PROCESS CHANGE NOTICE (PCN)

PCN Number:	PCN-23011	Means of distinguishing changed devices:
Date Issued:	June 1, 2023	☐ Product Mark:
Date Effective:	June 1, 2023	☐ Back Mark
Date Issued (+90 days):	August 30, 2023	☐ Date Code
		☒ No change to device
		Attachment: Yes ☐ No ☒

Product(s) Affected: Exar Legacy | MaxLinear HPA Products

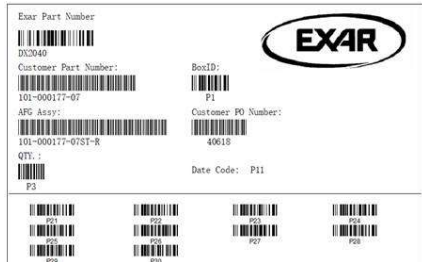
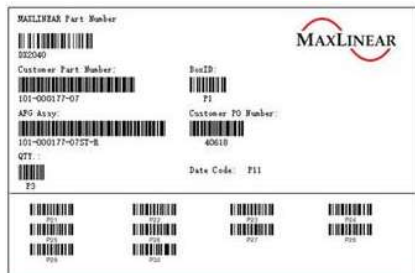
In 2023, MaxLinear will be converting all shipping labels for the parts noted from an EXAR format to MaxLinear's label. During this transition customers may receive either label.

This change affects only shipping and packing labels. This change will not affect the part number, part marking, manufacturing process or manufacturing sites.

Item	Current	New/Additional
Affected part: DX204001 only	MBB bag 	MBB bag 
Affected part: DX204001	Outer box label 	Outer box label 
ALL OTHER affected products	Reel, MBB bag, Inner box label 	Reel MBB bag, Inner box label 
ALL OTHER affected products	Outer box label 	Outer box label
